Woollahra Local Planning Panel (Electronic Meeting)

Wednesday 20 November 2024
10.00am - 2C & 4 Dumaresq Road, Rose Bay

LOCAL PLANNING PANEL DEVELOPMENT APPLICATION ASSESSMENT REPORT

On 7 November 2024, the subject application DA 204/2023 was tabled to the Woollahra Local Planning Panel (LPP) with a recommendation for conditional approval.

Figure 3 No demolition is to occur in the blue shaded area except as noted above.

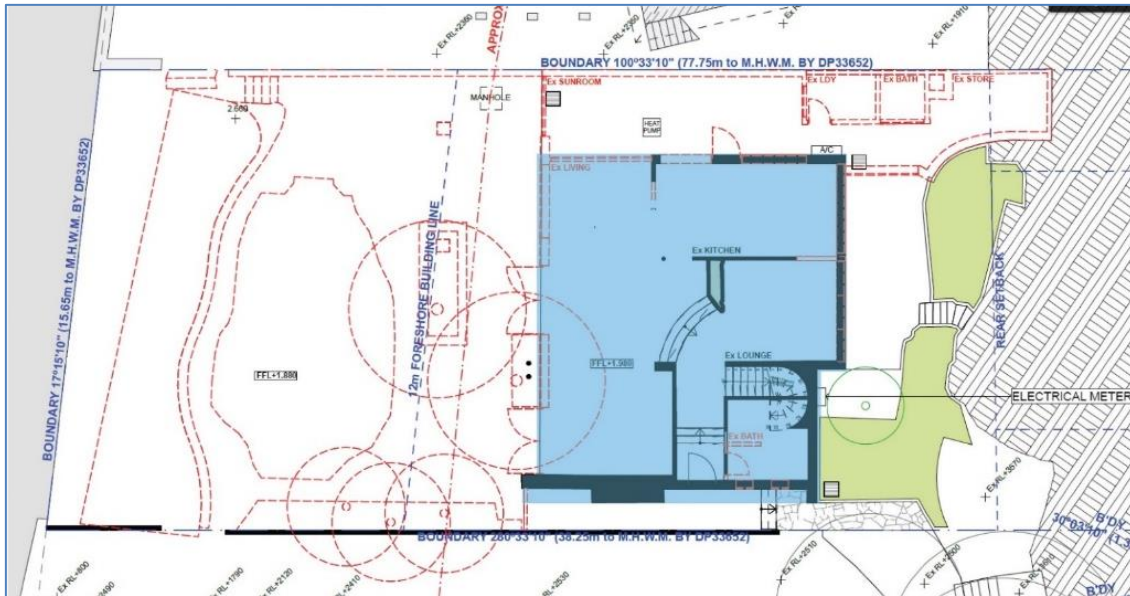
- a) On the ground floor, no demolition of any kind is to occur in the living area, kitchen, lounge, bathroom, stair or entryway (shaded blue, below) except the following:
 - i. The portion of the kitchen wall as required for the lift, the kitchen fixtures and finishes apart from the floor covering.
 - ii. The bathroom partition, furniture and finishes.
 - iii. The floor covering of the stair to the first floor (and only this stair).
 - iv. The windows and glass doors on the western façade. These must be replaced with windows and doors in the same fenestration pattern as shown in an elevation or detail drawing.

Figure 4 The proposed extension beneath the master bedroom on the ground floor (shaded blue) is not approved.

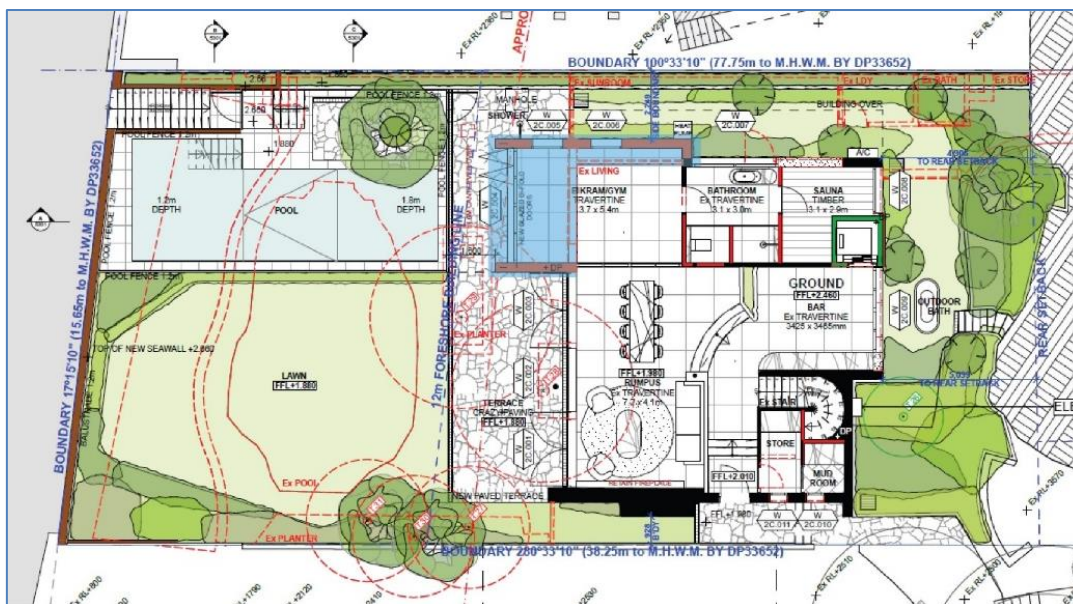
- b) The extension beneath the master bedroom on the ground floor (in the area shaded in blue below) is not approved. The extension to the north is not approved. The exterior walls must instead be retained as they are in this area.

Figure 5 The terrazzo tiling is to remain in the yellow-shaded area.

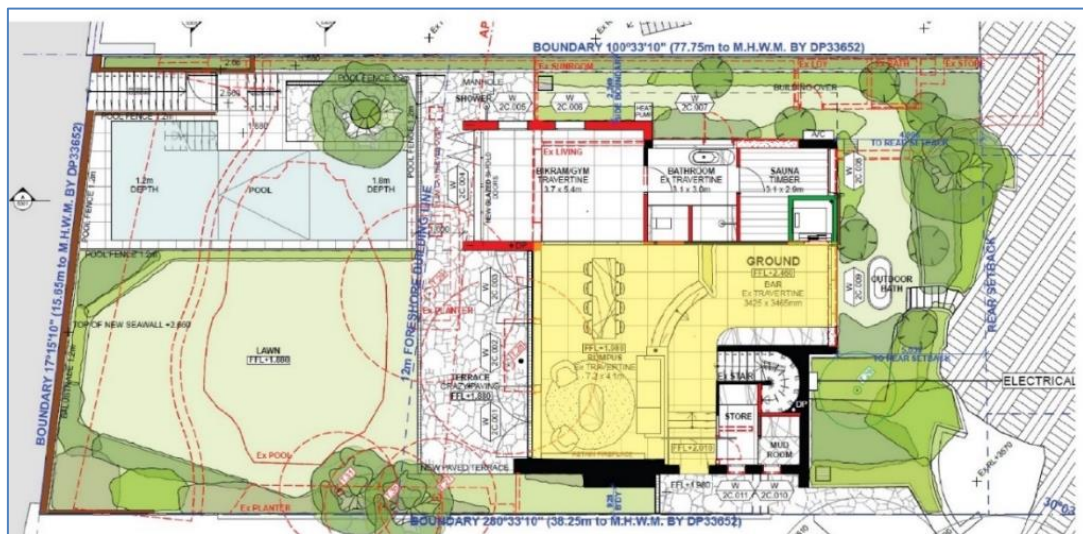
- c) The proposed travertine flooring is to be deleted and existing terrazzo tiling is to remain in the entryway, bar, and rumpus areas (shaded yellow, below). Recovered terrazzo from elsewhere should be used to replace sections of damaged terrazzo tiling in this area.

Figure 6 No demolition is to occur in the blue shaded area except as noted above.

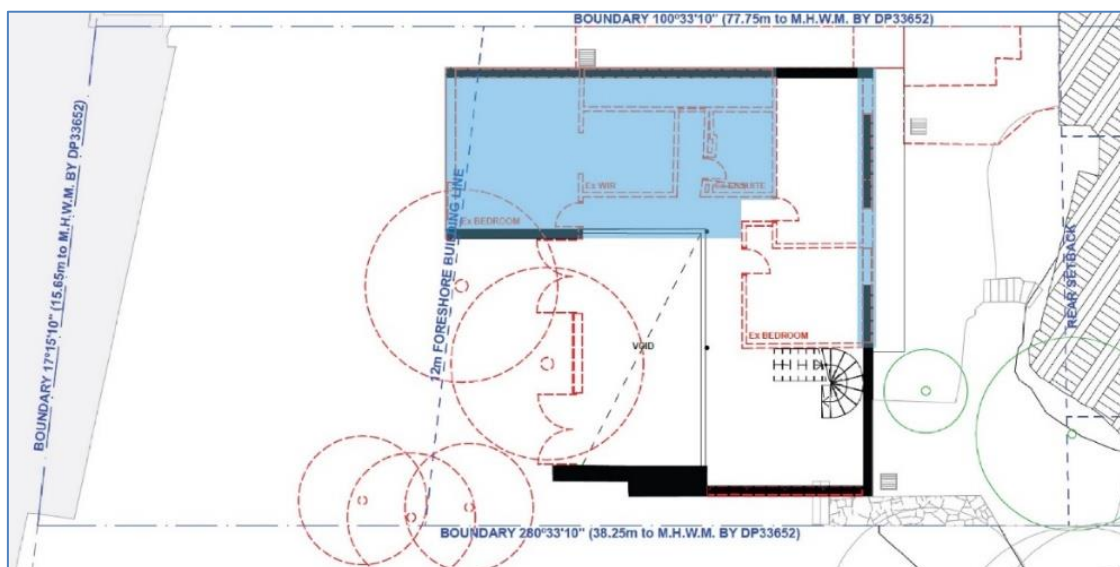
- d) On the first floor, no demolition of any kind is to occur in the master bedroom, adjoining corridor, eastern wall, northern wall including glass bricks or ensuites (shaded blue) with the exception of floor coverings.

Figure 7 The works in the blue-shaded area are not approved.

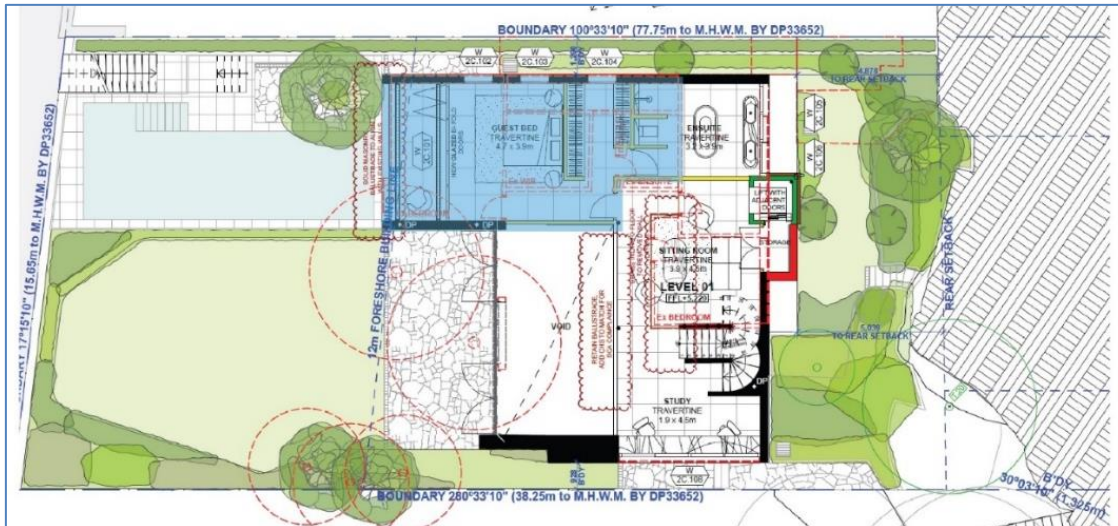
- e) The works to the master bedroom, bathrooms, new western balcony, corridor and void balustrade (in the shaded area in blue below) are not approved. This portion of the balustrade must instead be upgraded as with the rest of the balustrade.

Figure 2 – Stormwater plan extract showing drainage pits and overland flow path within immediate proximity of existing retaining wall.

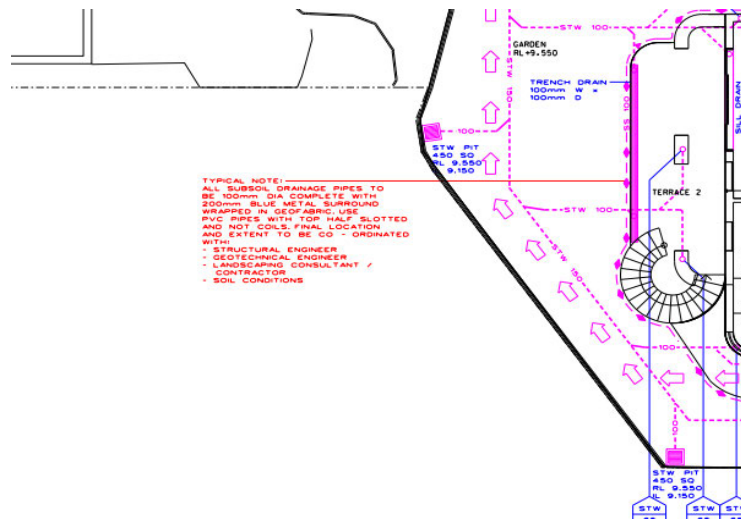
Our clients are extremely concerned as to the structural stability of this existing wall having regard to these proposed works in the absence of any structural certification. The correspondence at Attachment 1 from Penny Evans – Principal, Meridian Lawyers to owners of 4 Dumaesq Road dated 1 August 2022 details concerns previously expressed in relation to the structural adequacy and the risk of failure associated with ongoing uncontrolled stormwater flows over and through the wall. Such stormwater flows are depicted in the image over page.

Figure 6 - Originally submitted plan showing internalised access link

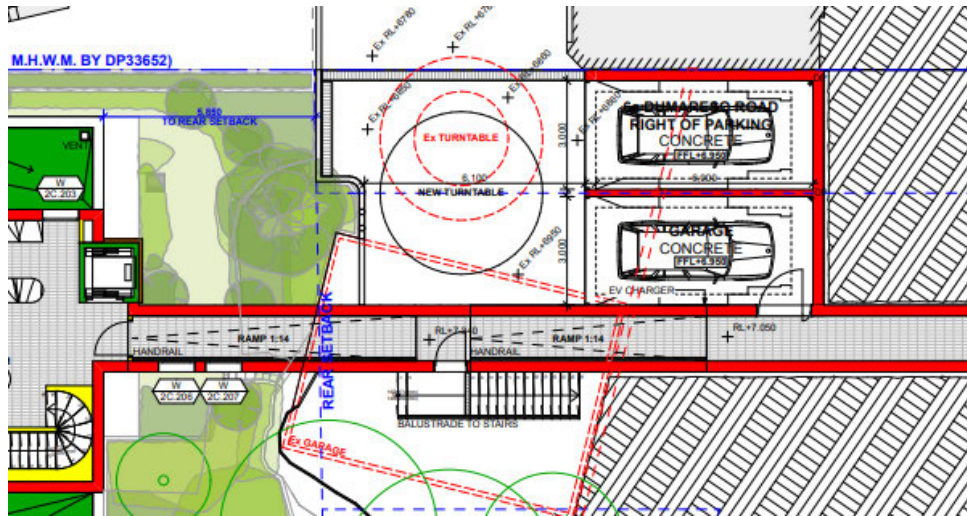
The solid enclosure of this external pathway link would remedy this situation with any windows having sill heights of 1.65 metres to match the screens required by draft condition C1.d. Given the immediate proximity of this walkway to our client's property we request that the application be amended to incorporate this internalised link alternatively a further condition be imposed requiring a 1.65 m high privacy screen being installed to the southern edge of the externalised access link for its entire length.

Figure 7 – Amended plan showing externalised walkway access link (not notified)

Figure 1 No demolition is to occur in the blue shaded area except as noted above.

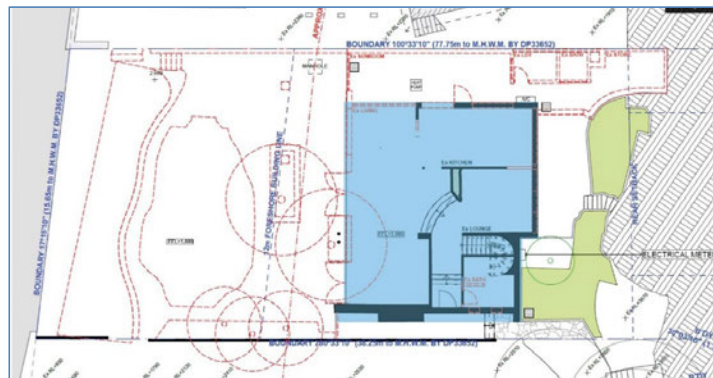
- a) On the ground floor, no demolition of any kind is to occur in the living area, kitchen, lounge, bathroom, stair or entryway (shaded blue, below) except the following:
- The portion of the kitchen wall as required for the lift, the kitchen fixtures and finishes apart from the floor covering.
 - The bathroom partition, furniture and finishes.
 - The floor covering of the stair to the first floor (and only this stair).
 - The windows and glass doors on the western façade. These must be replaced with windows and doors in the same fenestration pattern as shown in an elevation or detail drawing.

Figure 2 The proposed extension beneath the master bedroom on the ground floor (shaded blue) is not approved.

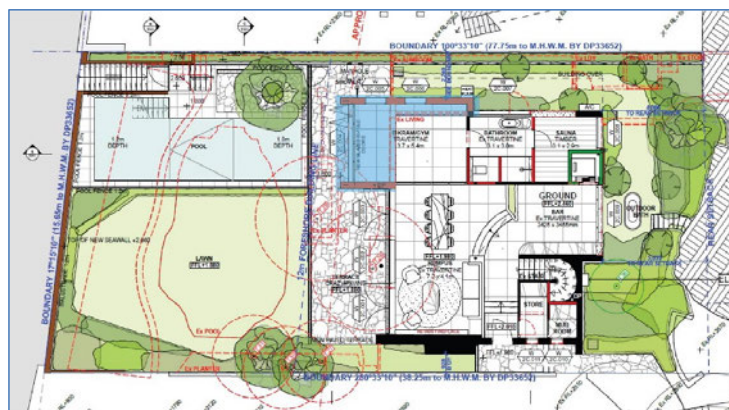
- b) The extension beneath the master bedroom on the ground floor (in the area shaded in blue below) is not approved. The extension to the north is not approved. The exterior walls must instead be retained as they are in this area.

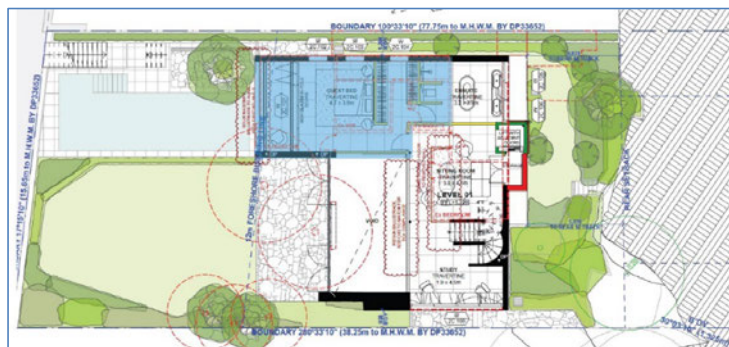
d) On the first floor, no demolition of any kind is to occur in the master bedroom, adjoining corridor, eastern wall, northern wall including glass bricks or ensuite (shaded blue) with the exception of floor coverings.
